AGENDA
PLANNING COMMISSION MEETING
WEDNESDAY, SEPTEMBER 9, 2020
7:00 P.M.
Maggie Osgood Library
70 N. Pioneer Street

- a. Land Use File 2019-06 – Crestview Subdivision (Map 10-01-11-00, Tax Lot 501)
 - Public Hearing
 - Commission Deliberation
 - Commission Decision

1. **Proposal.** The Planning Commission is being asked to review and render a recommendation onto City Council for final action, on a 17-lot subdivision for property located at Assessor's Map 19-01-14-021, Tax Lot 05000. The subject property is owned by Bahen Investment Group, LCC Investments. The surveyor for the project is Lloyd Tolbert of Tolbert Associates, LCC and the engineer is Dennis Boeger of Boeger Associates, LCC. The subject property is zoned R-1 Single Family Residential. The subject property currently is vacant but cleared of most trees and brush. The proposed subdivision is the next phase of the Sunset Hills subdivision that is currently located adjacent to the subject property. The applicant is proposing to create 17-lots as shown on the tentative map and are intended to have single-family homes built on them.

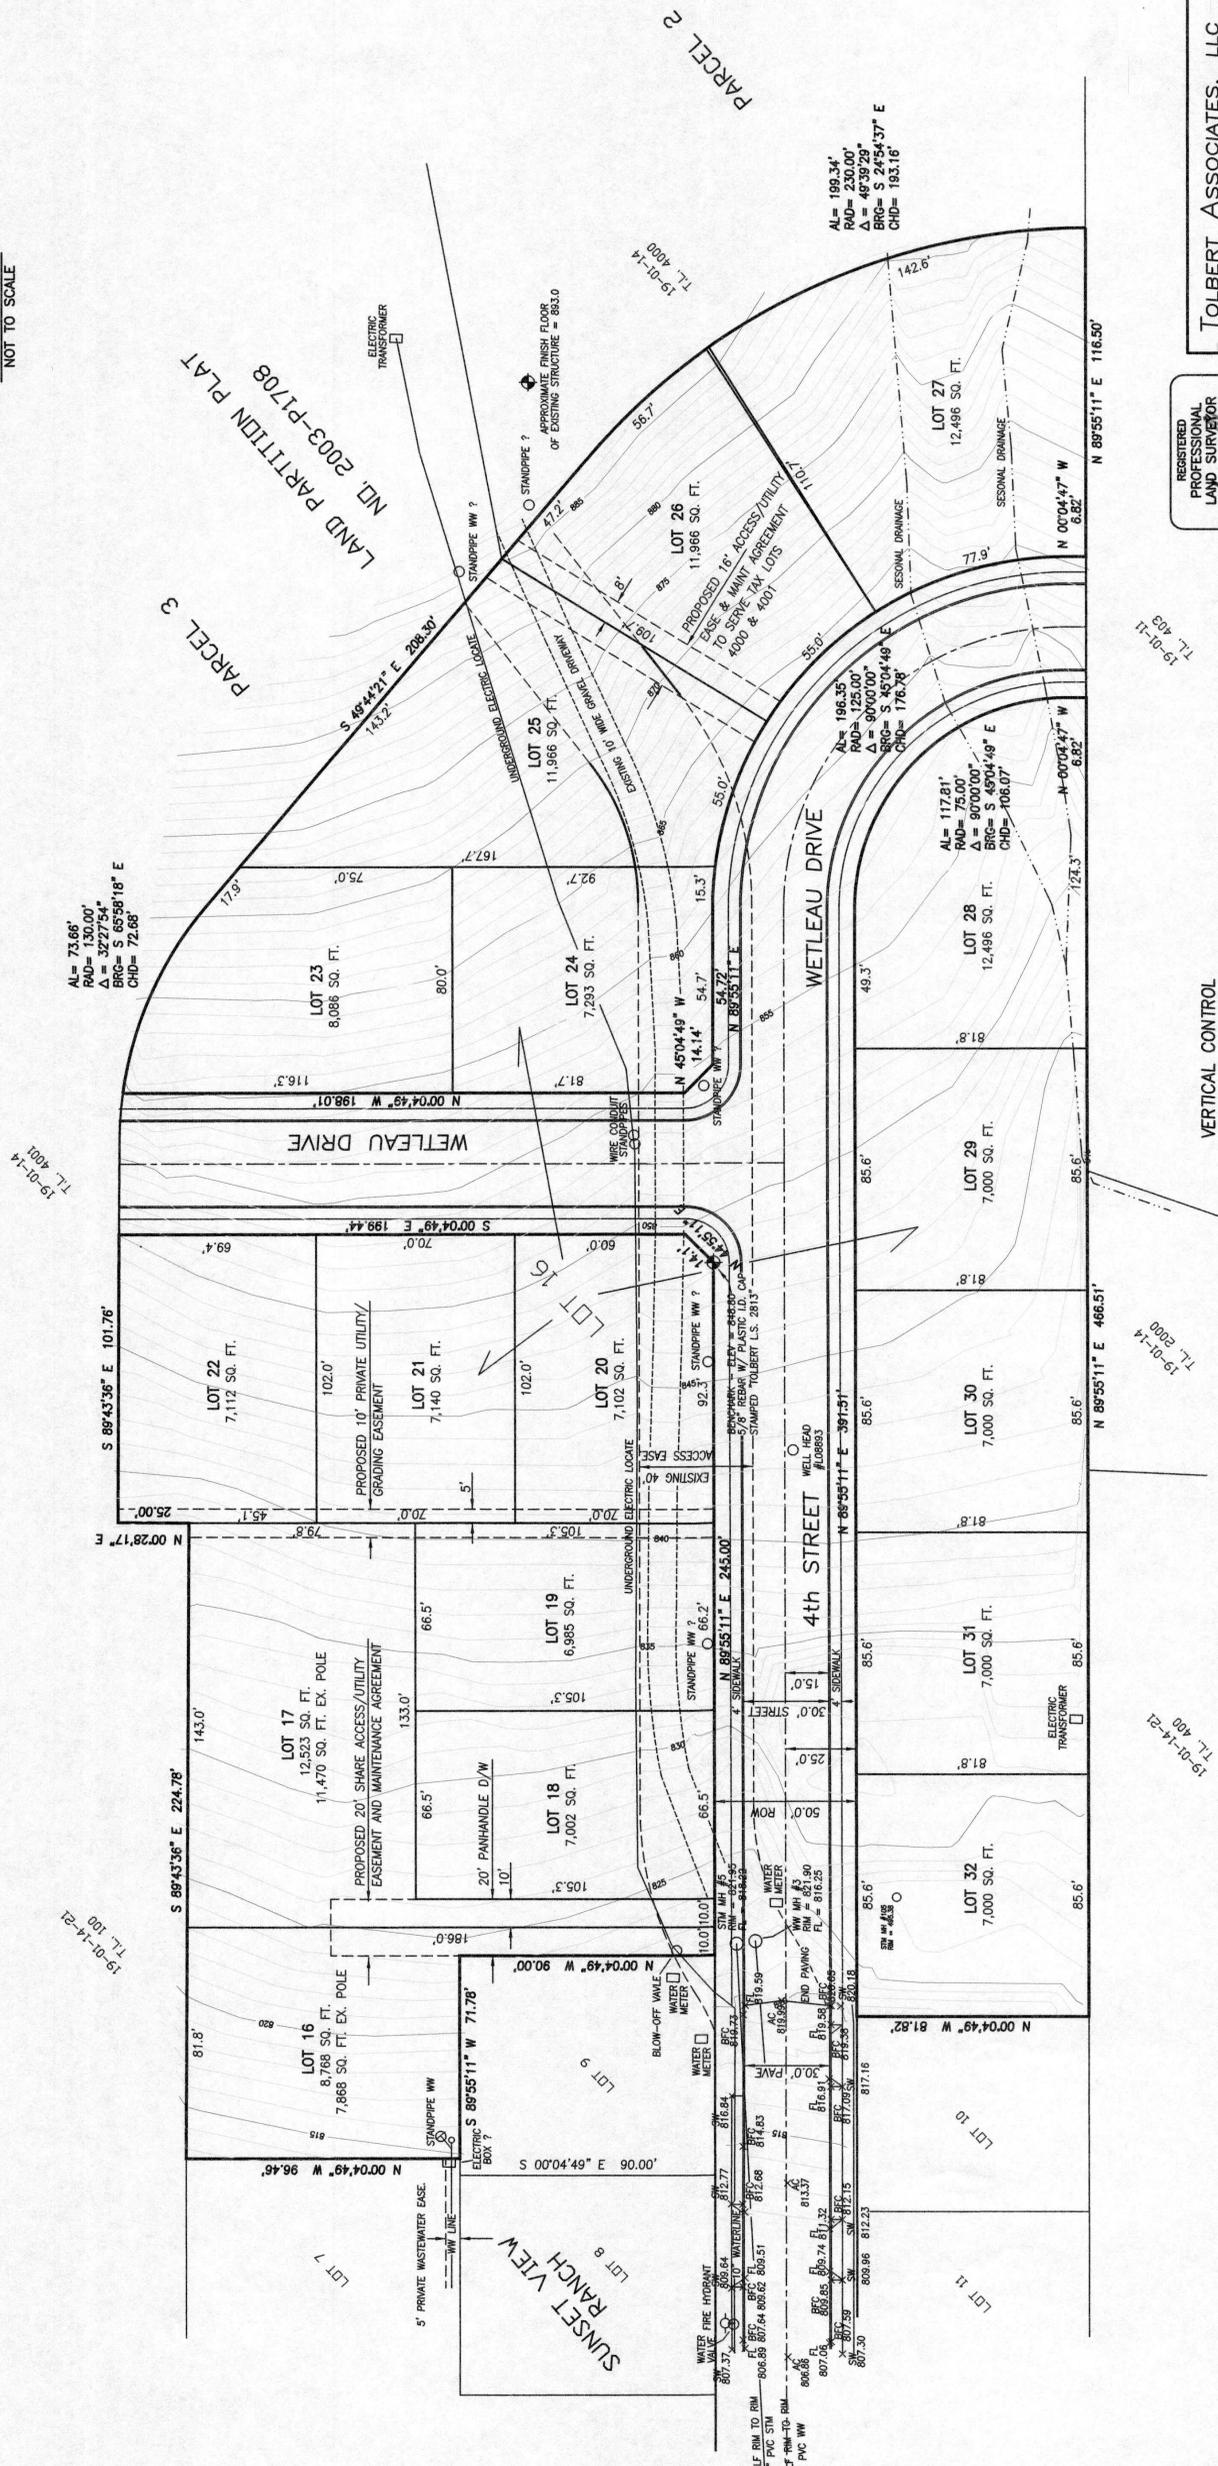
16. Please extend the window of the Typical Lot Drainage + Layout to show the sidewalk and driveway grades.
17. Drainage easements will be required wherever drainage from any lot drains onto, or across, any other lot. This would apply to lots 17, 19, 20, 21, 23, 27, 28, 29.
18. Label dashed line that runs through the site. Is this existing ROW?
19. Label north/south street.
20. Typical Street Section Detail; See Lowell Standard Detail 201 for local street detail, detail 202 for curb and gutter details, and 204 for sidewalk detail. Need an integral curb & gutter, base course should extend under curb, sidewalk should be a minimum of 5' wide, measured from back of curb.
21. Construction notes need to identify which detail they are referring to, rather than just the page.
22. Clarify on which lot the 16' easement to the existing house is on. Where is the PL?

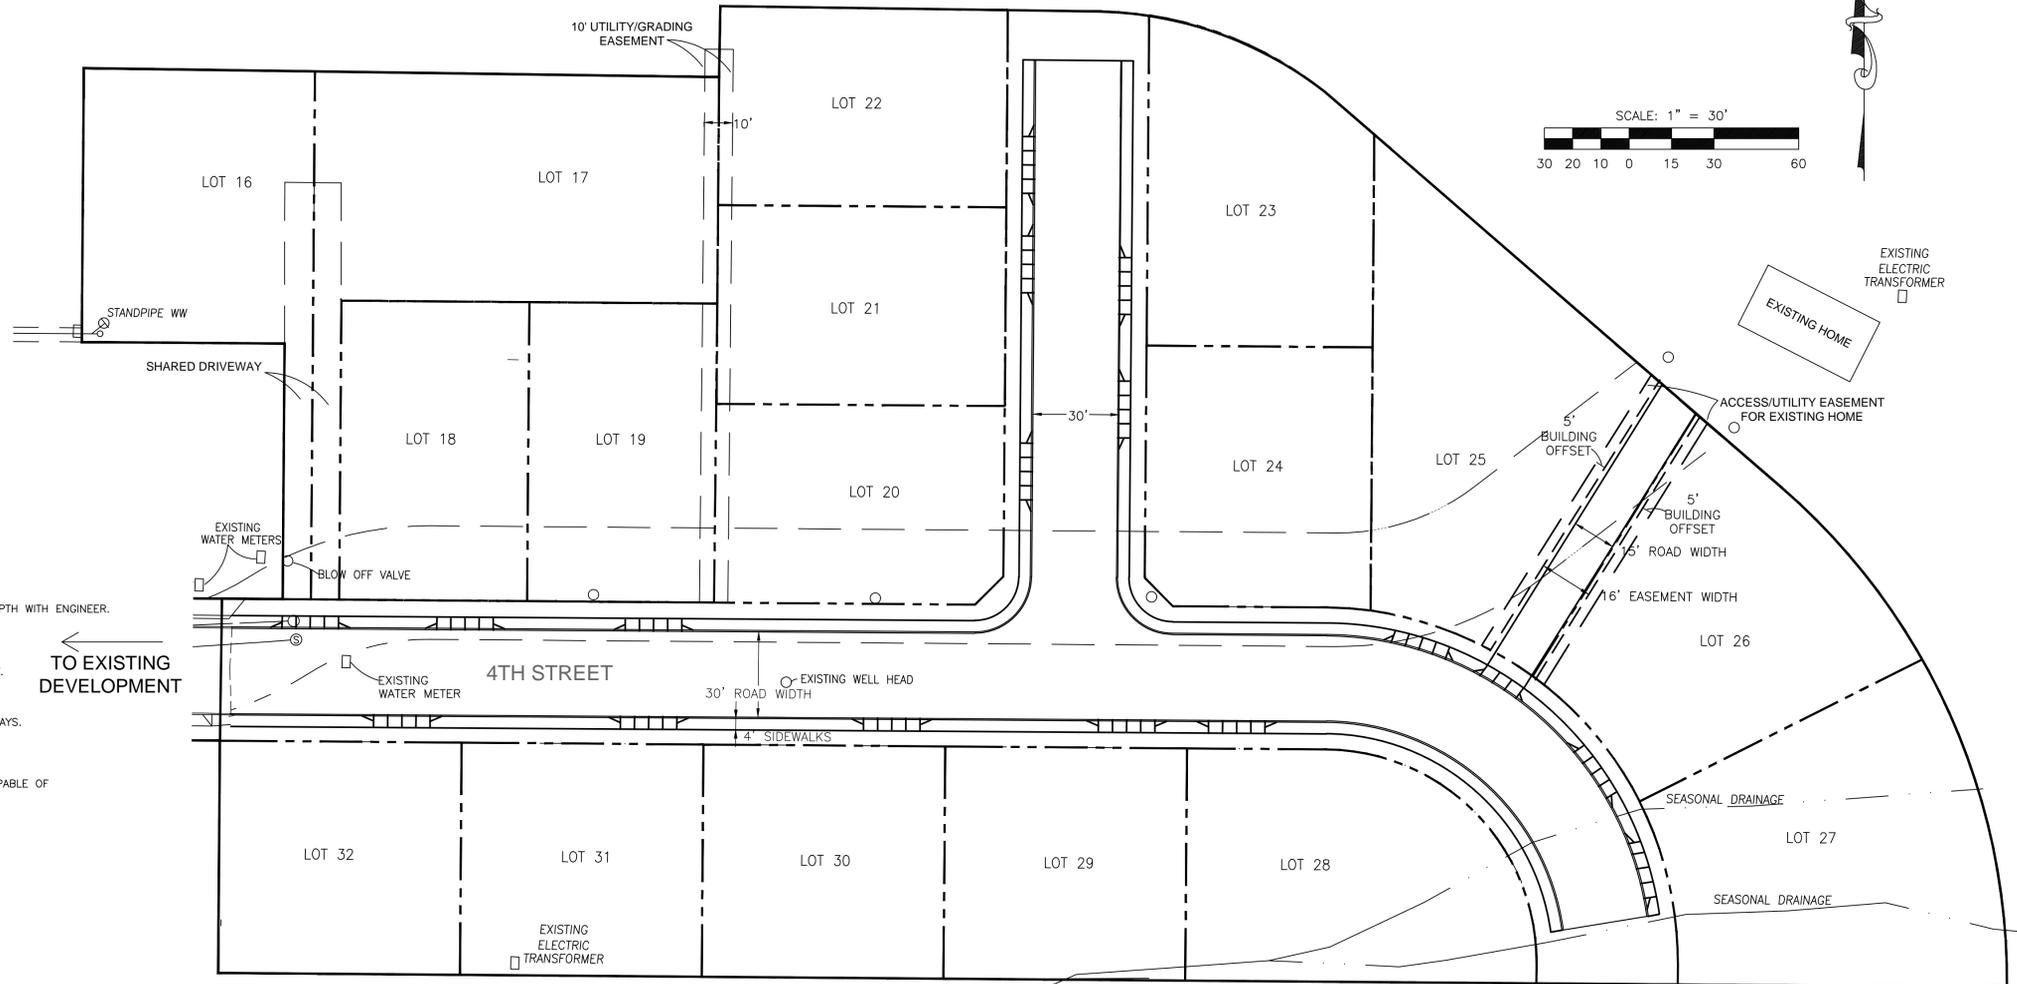
26. Calculations need to be included in the Drainage Report showing that the catch basins (Drop Inlet per Detail Sheet 7) will capture the entire runoff volume. Catch basins on a continuous grade need to be calculated differently than those in a sag.
27. Paving, Grading & Miscellaneous note #71; Driveways (at least the public portion and ramps) need to be 6" concrete.
28. Section B shown at the back of lot 27 does not refer to where the detail is shown. Add sheet number.
29. At the east end of the street, add inlet and outlet grades to the 18" CMP. Show that the road extension will be able to cross over the culvert with appropriate cover.
30. Note in bottom right corner of plan sheet has typo. "... around NE development..."
31. Show water and sewer pipes (lightly) and call out crossing separations between all utilities.

Sheet		
7 of 12		
REVISIONS		
No.	Description/Date	By

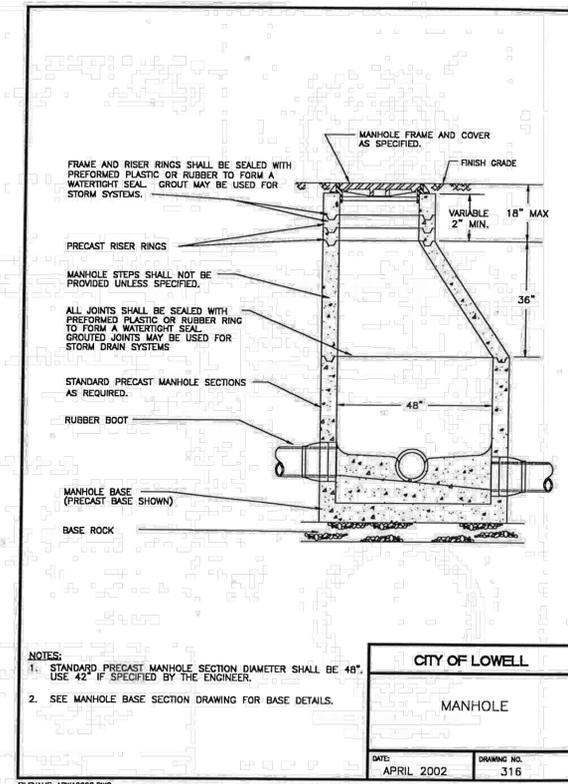
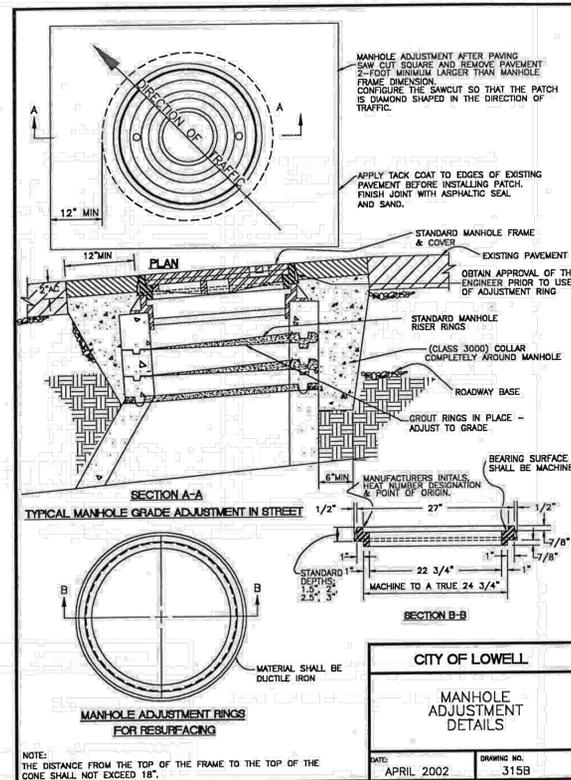
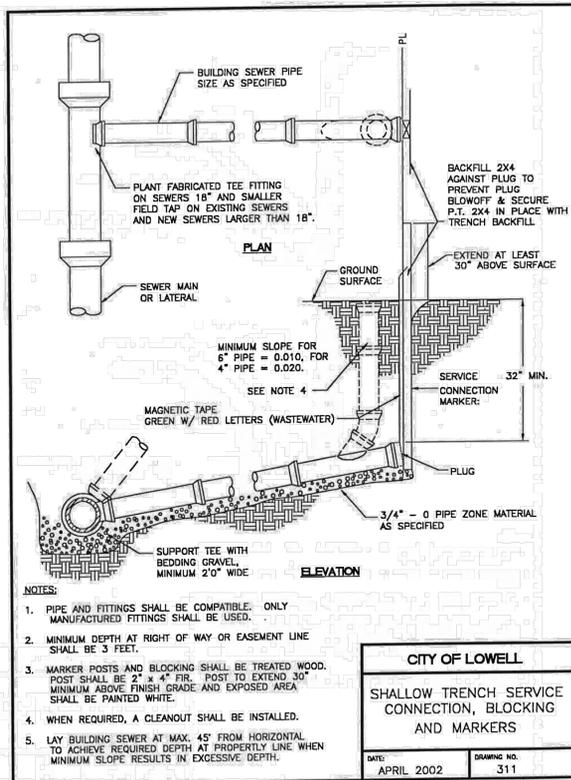
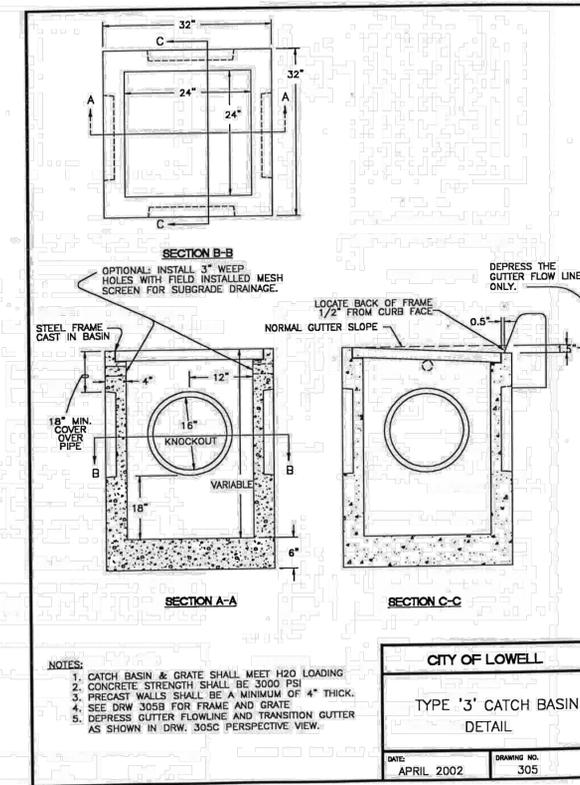
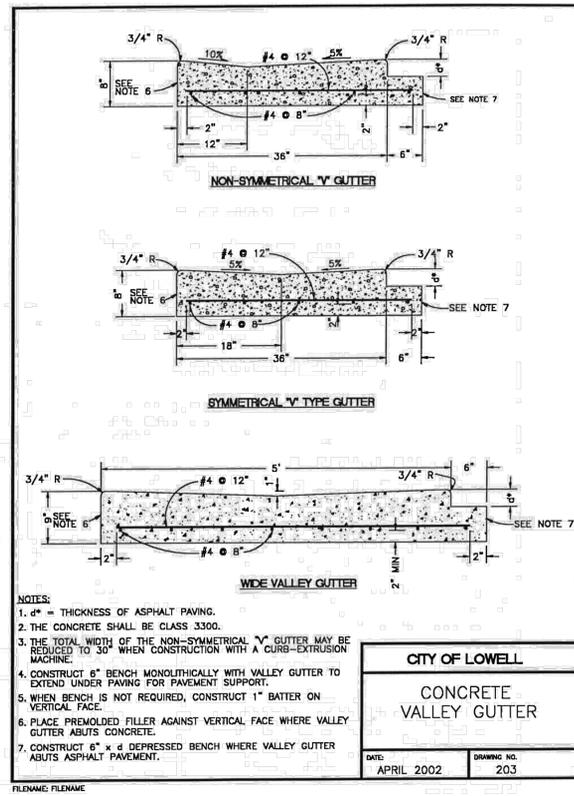
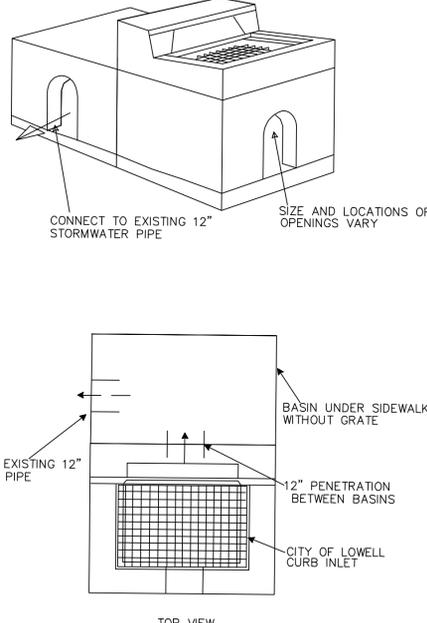
53. 4" cleanout detail should refer to SD 311 on sheet 8 for additional requirements.
54. 4" cleanout detail should show a temporary plug or cap in the lateral.
55. Custom Catch Basin Inlet #1 should have an access over the pipe. Access can be a vault style door, or a manhole. Blind connections are not allowed.
56. Sidewalk and Curb Drain detail. Provide calculations that show that a 12" x 3" tube will convey the peak stormwater beneath the sidewalk.
57. Sidewalk and Curb Drain detail. Provide reinforcement of concrete above the tube. At 2½" to 3" thick, the concrete will crack.

FIGURE D103.1
DEAD-END FIRE APPARATUS ACCESS ROAD TURNAROUND

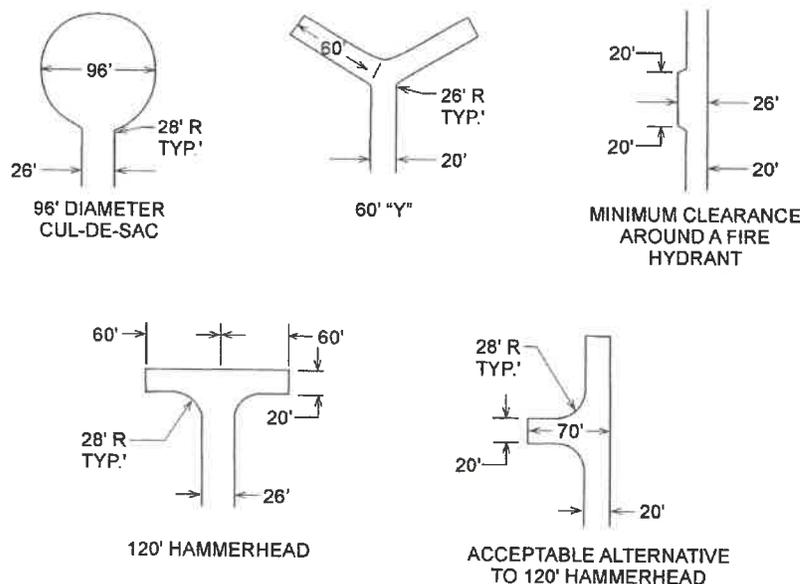
Discussion: The Fire Chief of the Lowell Rural Fire Protection District (LRFPD) has issued comment that turnarounds are needed at the dead-ends of Wetleau Drive. Lowell Development calls for turnarounds on dead-end streets that are planned to extend in the future. Per the Master Road Map, both the northerly and southerly extensions of Wetleau Drive are planned to extend to connect future rights-of-way. These two dead-ends streets will need fire-department approved turnarounds placed at the terminus to allow for adequate and safe fire and emergency vehicle backing and turnaround. The inclusion of two turnaround at the dead-ends of Wetleau Drive will be a condition of approval, prior to final plat approval.

I really hope everyone understands that I am in full support of these houses going in. However, there is a reason for the Fire Codes set the way they are. I cannot compromise the overall safety of the Fire personnel or the community members. I did address the issue back at the first meeting along with the City Manager. Oregon Fire Code is available for everyone to see. It is my job to point out these issues when I see them. The last set of plans did not show the proper turnaround at the dead end of either street. Attached is Oregon Fire Code Appendix D Section D103.4 Dead Ends as well as LC 15.708.

Condition of Approval #4: Prior to final plat approval, applicant shall construct and show two fire-department approved turnarounds on the final plat at both dead ends of Wetleau Drive. Details for construction of turnarounds shall be submitted to the City Engineer for review and approval, as part of the construction drawing phase. Staff include **Attachment G**, as fire-department approved turnarounds.
